# TOWN OF AMHERST PLANNING COMMISSION Wednesday, March 6, 2024 AGENDA

### **REF: Amherst Presbyterian Church**

The Town of Amherst and VDOT completed a review of the submitted site plan, dated November 20, 2023 (seal), and received November 27, 2023, for Amherst Presbyterian Church located at 163 Second Street, Amherst, VA. Agency comments with our responses are as follows:

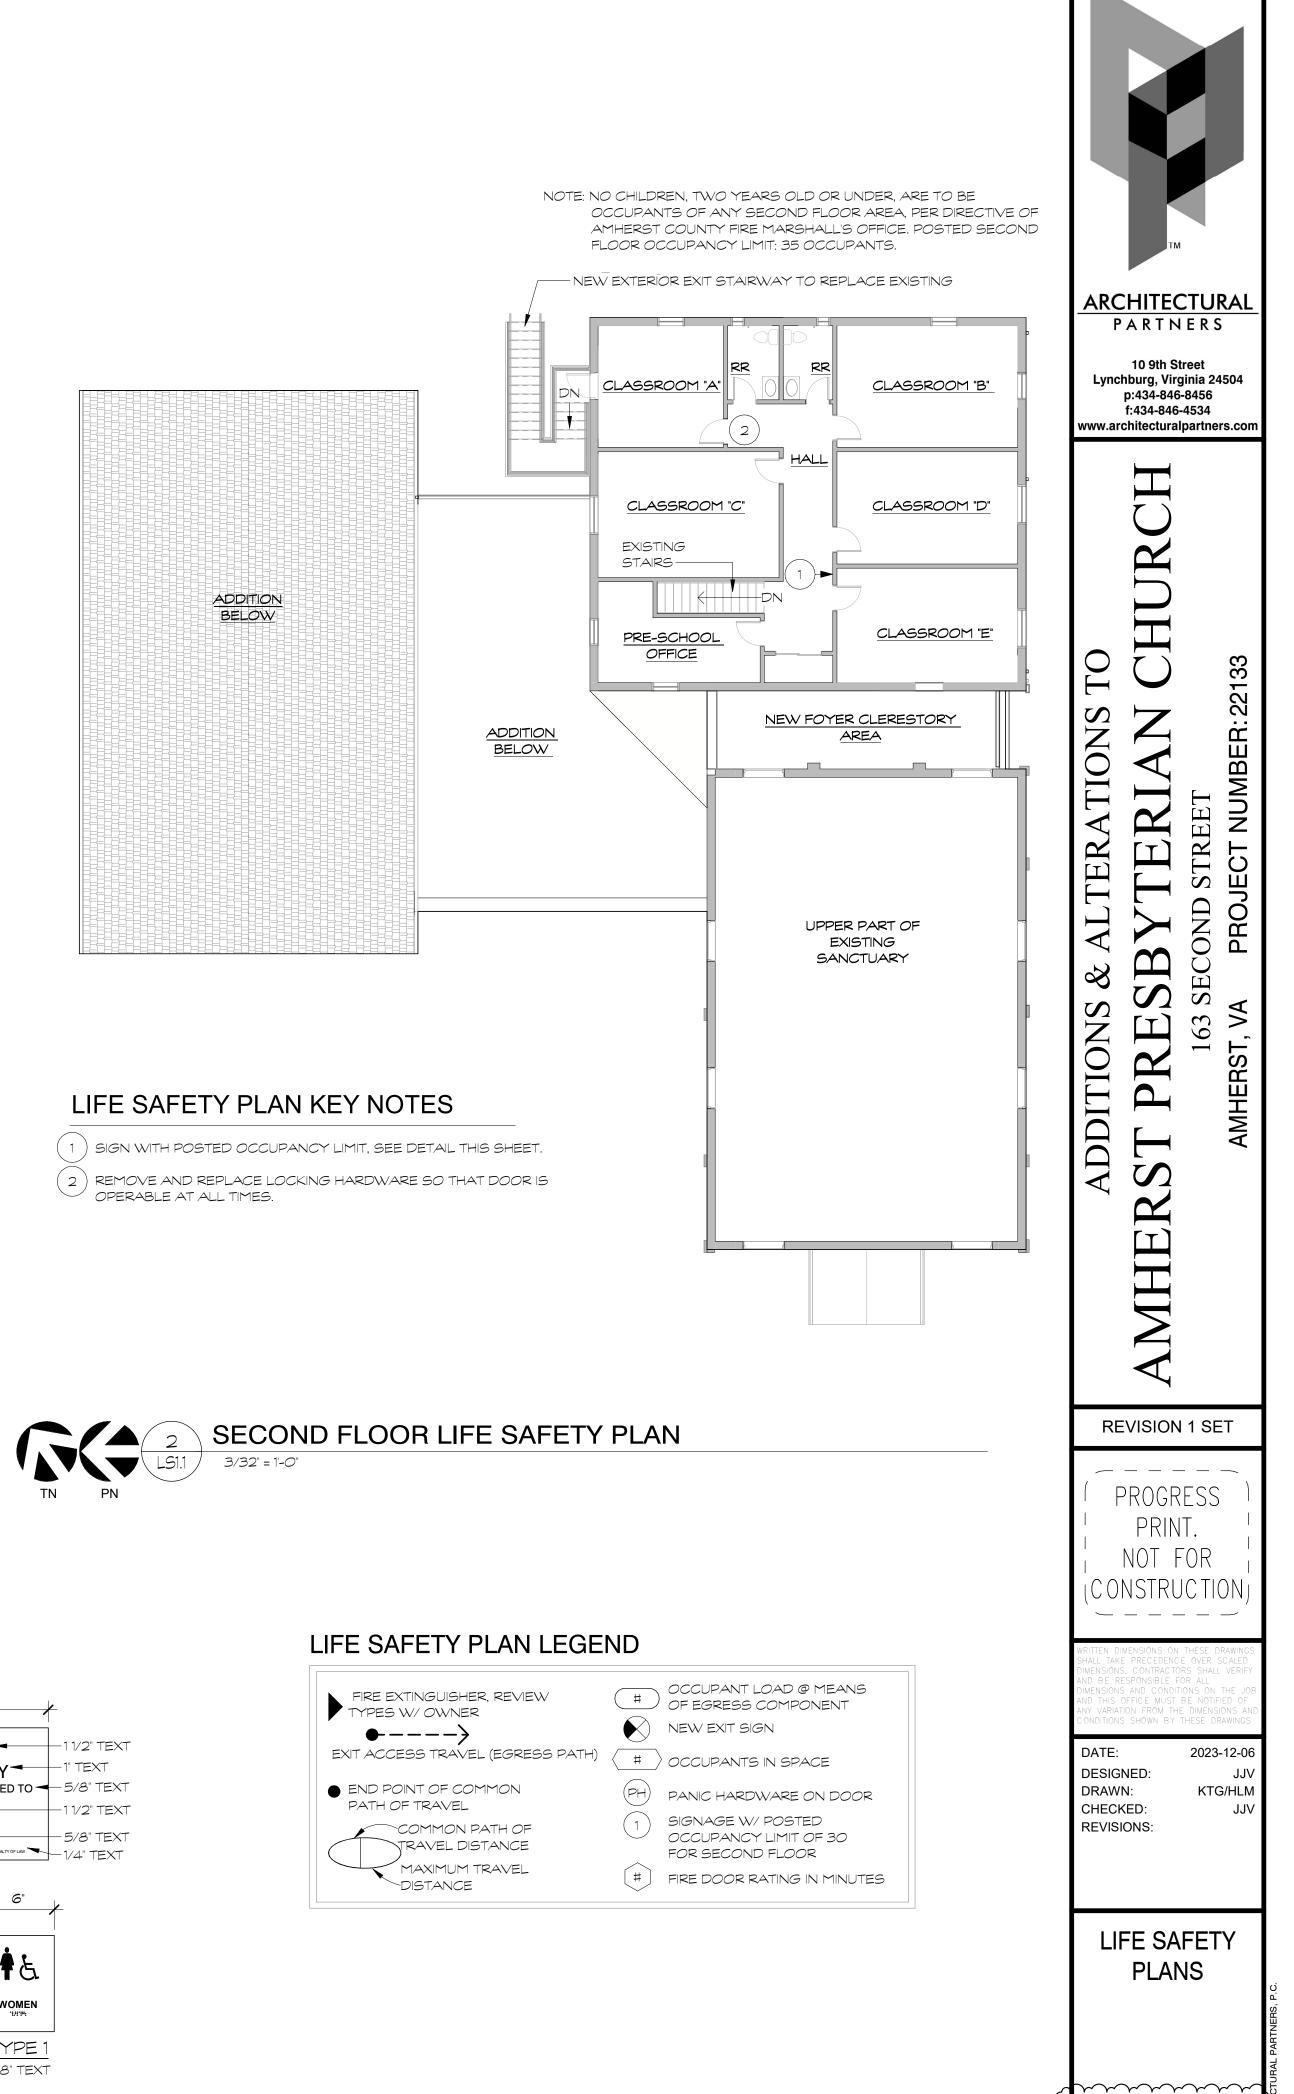
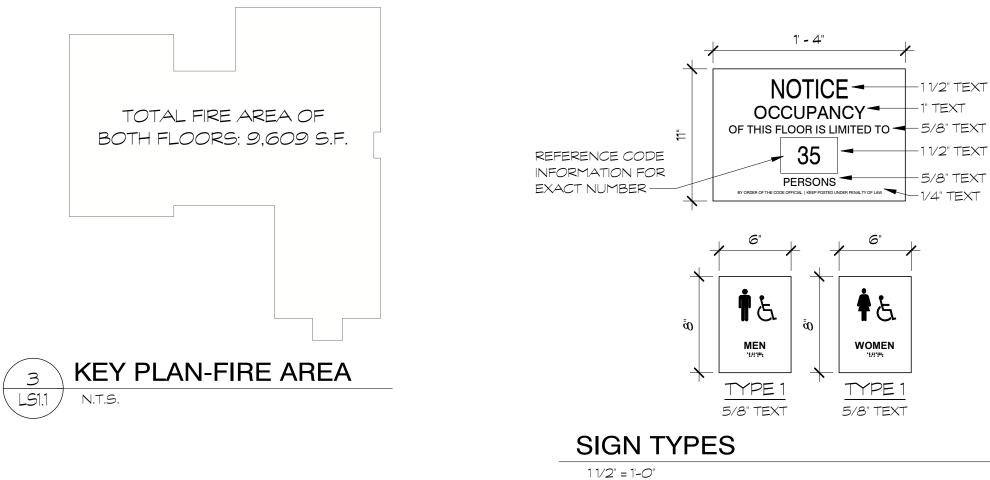
1. The plan shows a 1-inch water meter. Provide calculations to support meter size.

2. Plans do not show detailed connection to the sanitary sewer line. More information is required, including size, grade, location, pavement patching, etc.

3. Stormwater pond is adjacent to a door and a sidewalk that is not fenced. Recommend fencing the stormwater pond to prevent drowning potential.

4. Provide fire suppression plans or compliance with fire code.

5. Provide elevations.

6. Provide parking calculations and required parking. Checklist states that you are using on-street parking. That is not allowed within the Code.

- 1. VDOT has identified the following items from the VDOT Lynchburg District Site Plan Checklist (attached) that need to be addressed:
  - a. Item #4, please add state route numbers to the vicinity map.

3. The proposed stormwater facility shall be designed to have 2' of freeboard between the 100year WSE and the top of dam elevation when there is no emergency spillway.

4. Revise the stormwater basin outfall pipe to be a 15" reinforced concrete pipe with an 8" water quality orifice per the 2016 VDOT Road and Bridge Standards.

5. Revise the dam top width to be a minimum of 8" per Appendix A of the Virginia Department of Environmental Quality Stormwater Design Specifications.

6. Please show the existing non-standard curb and gutter as being removed and replaced with VDOT Standard CG-6.

7. Please show the existing drop inlets as being removed and replaced with VDOT Standard DI-3 to function with the standard curb and gutter. The existing 10" pipe between the two will need to be replaced with an appropriately sized pipe.

8. Please provide a VDOT Standard CG-12 where the proposed sidewalk is shown ending at the existing curb line along Route 1115. The sidewalk may be better suited to run parallel to Route 1115, behind the curb and gutter, which would remove the need for a CG-12 if connected appropriately to existing sidewalk on site.

Response: The water line size is revised to a  $1 \frac{1}{2}$  water line per the calculations provided on a supplemental document. A 1 meter is proposed for the new connection and is detailed on sheet D-2.

*Response: There is an existing sanitary sewer connection to the public sewer system. The sanitary sewer line for the addition is proposed to connect to the existing cleanout with a typical "wye" joint.*

*Response: The recommendation is noted and the church has decided not to pursue fencing around the stormwater pond.*

*Response:* No fire suppression is proposed. Compliance with the fire code will be provided by the architect.

Response: Building Elevations are provided on a supplemental document.

Response: The daycare center and church services are existing uses for the building. The proposed addition is a fellowship hall that does not increase capacity for the sanctuary or daycare center, and therefore does not necessitate additional parking requirements beyond the existing parking provisions.

Response: Route numbers and road names are added to the Vicinity map on sheet C-1.

# Response: The proposed stormwater facility is three (3) feet deep and earthen embankment specification for the two (2) feet of freeboard for the 100-yr storm does not apply.

# Response: The stormwater basin outfall pipe is revised to a 15" RCP pipe with an 8" orifice. Calculations are updated on sheets C-8 and C-9.

Response: The proposed stormwater facility is three (3) feet deep and earthen embankment specification for the eight (8) feet wide dam top does not apply.

### Response: No road improvements are proposed for Mountain View Drive.

### Response: No road improvements are proposed for Mountain View Drive.

Response: VDOT Standard CG-12 is proposed at the end of the sidewalk along Mountain View Drive.

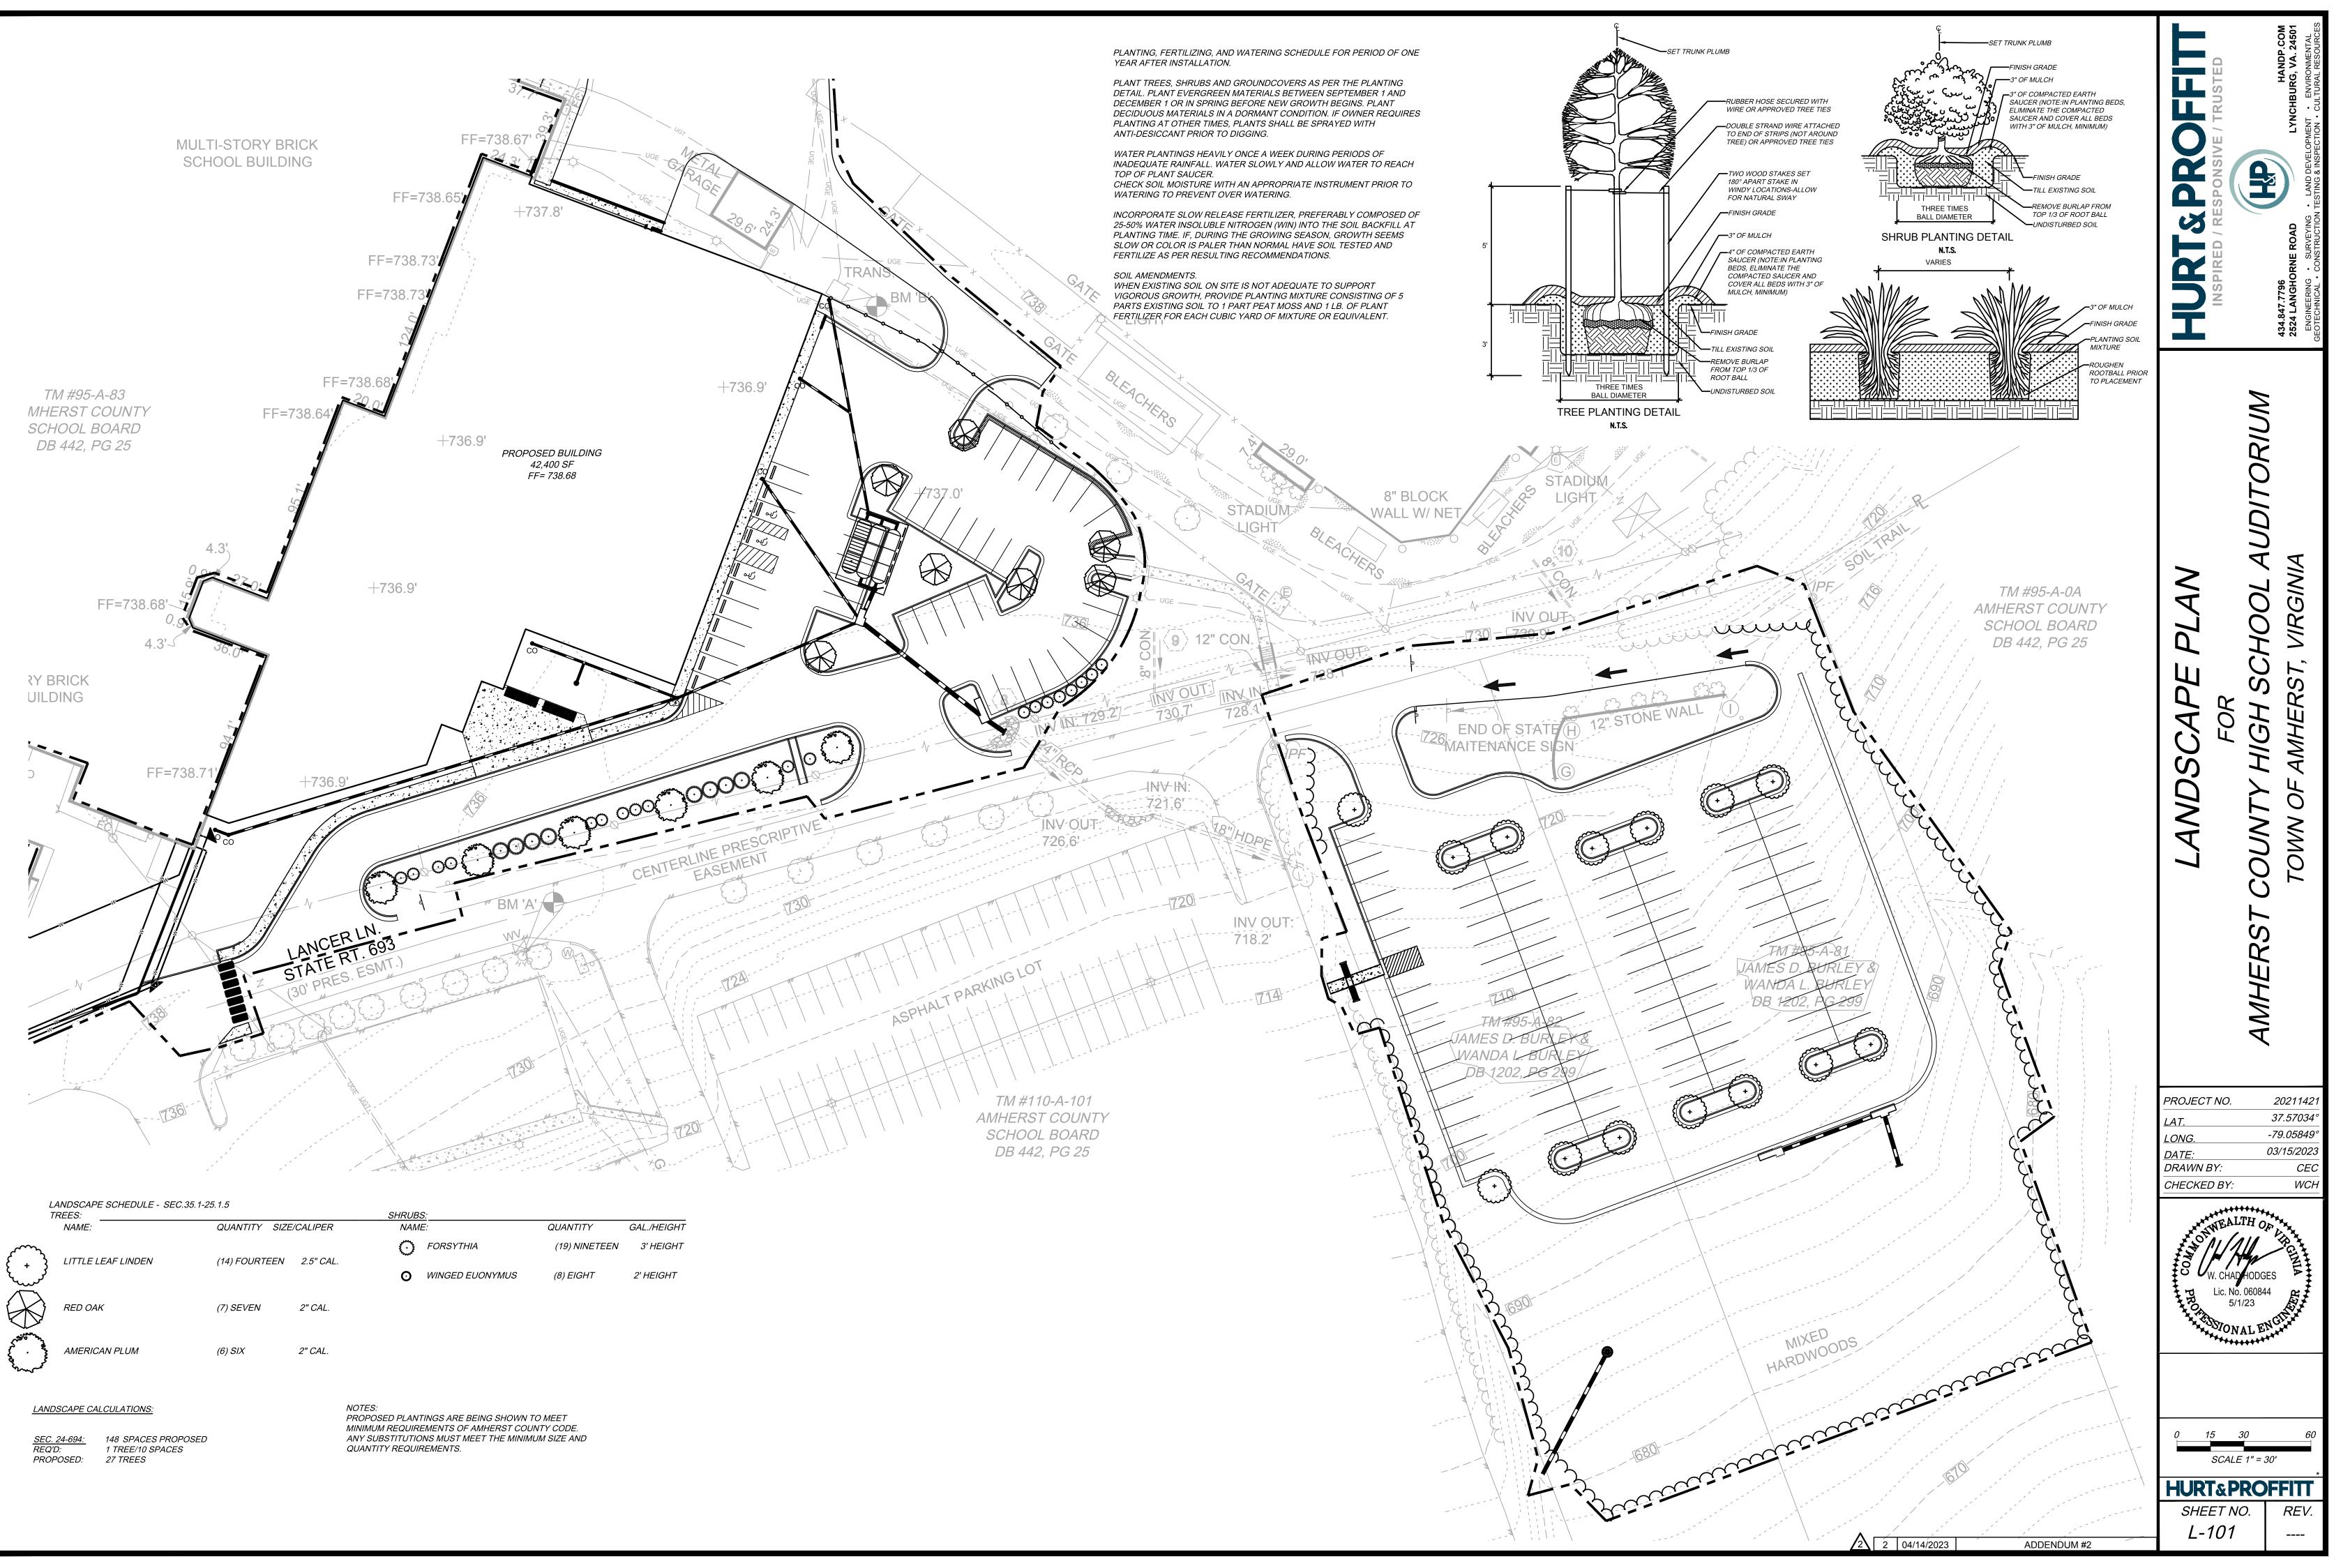
Superintendent Dr. William Wells (434) 946-9387 wwells@amherst.k12.va.us	TO:	Mrs. Sara E McGuffin Town Manager Town of Amherst				
		Town of Amherst Planning Commission				
School Board Christopher T. Terry Chair District 3 (434) 528-6499 Ext. 18008 cterry@amherst.k12.va.us	FROM:	Gary M. Roakes Maintenance Supervisor Amherst County Public Schools				
Abby J. Thompson	DATE:	February 28, 2024				
Vice Chair At-Large (434) 528-6499 Ext. 18010 athompson@amherst.k12.va.us	RE:	Request to revise Amherst County High School Approved Site Plan				
Lori R. Saunders District 1 (434) 528-6499 Ext. 18009 <u>lrsaunders@amherst.k12.va.us</u>	Amherst County Public Schools is requesting to modify the approved site pla the Amherst County High School addition located at 139 Lancer Lane. We a requesting to remove the concrete islands around the six light poles in the ne					
Dawn N. Justice District 2 (434) 528-6499 Ext. 18002 <u>djustice@amherst.k12.va.us</u>	parking lot. Removing these islands will increase the parking capacity from 100 parking spaces to 112.

Priscilla M. Liggon District 4 (434) 528-6499 Ext. 18005 pliggon@amherst.k12.va.us	The six light poles will be centered between four sparking spaces in each location and rest on a concrete base approximately three feet tall to protect the pole which replicates the existing Junior parking lot. Eliminating the islands will also help facilitate in maintenance matters such as snow removal.
